PINS ref: EN010093

**Greater London Authority and Transport for London  
Post Hearing Written Submission of Oral Case and  
Responses to Further Information Requested by the  
Examining Authority**

1. This note summarises the case made by the Greater London Authority and Transport for London at the Issue Specific Hearing for Environmental Matters on 6 June 2019 and the Issue Specific Hearing for the draft Development Consent Order on 7 June 2019 with regard to the Riverside Energy Park project, submitted by Cory Riverside Holdings Ltd ('the Applicant').

**Figure 1** – Extract from London Riverside OAPF, showing existing and proposed land uses.

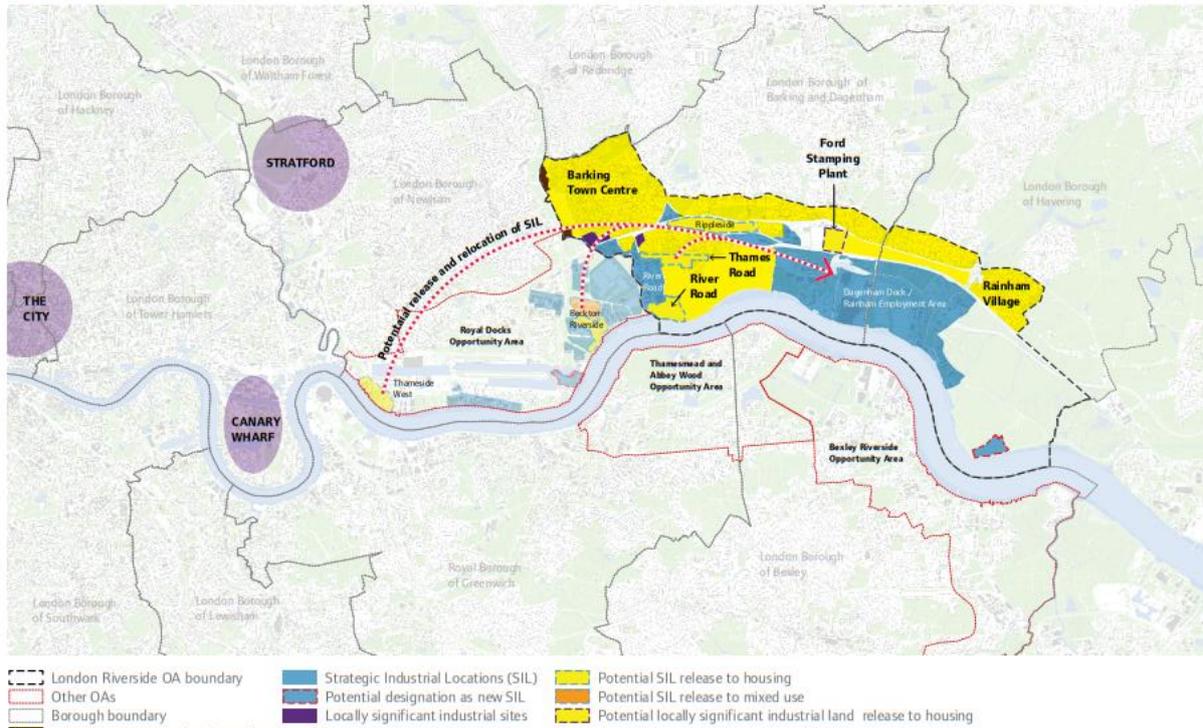
58. Figures 1 and 2 in Appendix 4 are extracted from the OAPF: Figure 1 indicates the land use strategy and Figure 2 shows the proposed built form. Residential development is primarily to be located to the south of the A13 in Havering and on Barking Riverside in Barking and Dagenham. When the plans for the Opportunity Area are compared with the expected air quality impact plumes, as provided in the Applicant's Environmental Statement, it is clear that a part of the OA is within the isopleths showing areas impacted by increased nickel, arsenic and NO<sub>2</sub> concentrations at ground level, as shown in figures 7.5 – 7.7 in the applicant's ES, and a

**Figure 2** – Extract from London Riverside OAPF, showing London Riverside built form

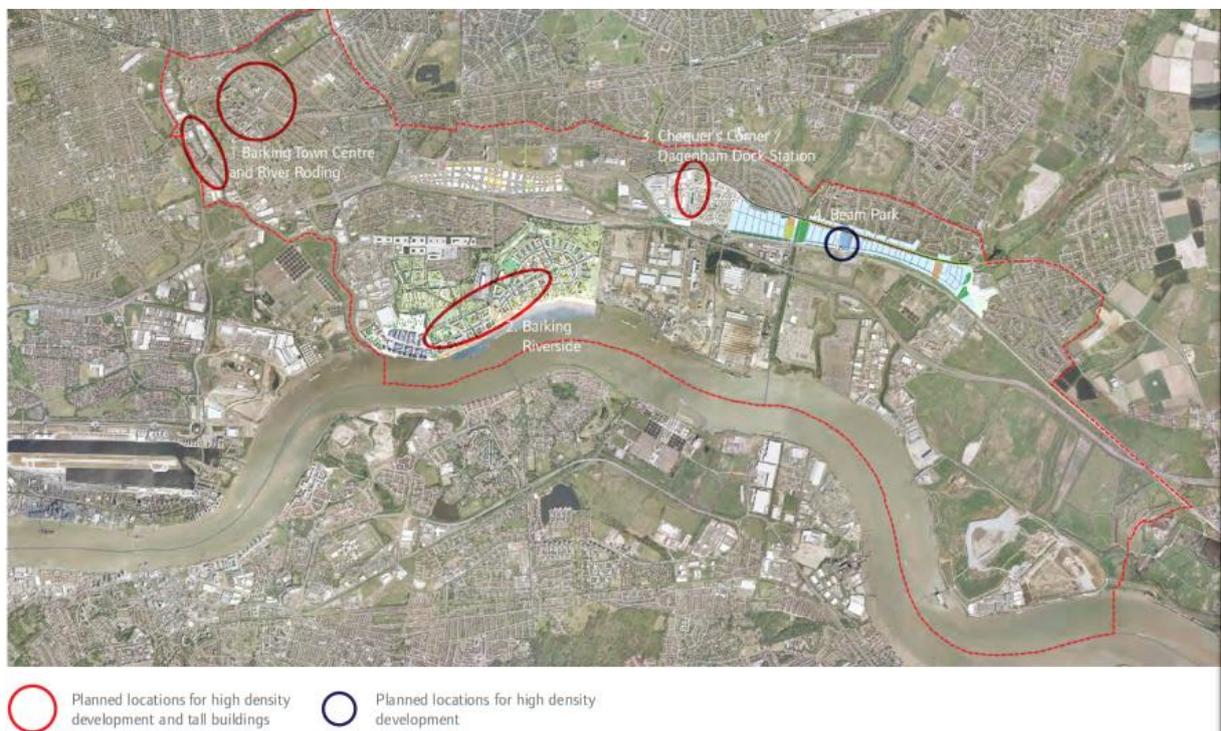
62. In addition to these consented strategic developments, there are a number of residential-led developments in the Beam Park area (shown in figure 2) that are presently in their pre-planning application phase. Whilst the density of the remainder of the Beam Park / Rainham area is expected to be lower rise than the Beam Park site itself, the draft London Plan and London Plan seek that opportunity areas maximise development potential, particularly around transport nodes.
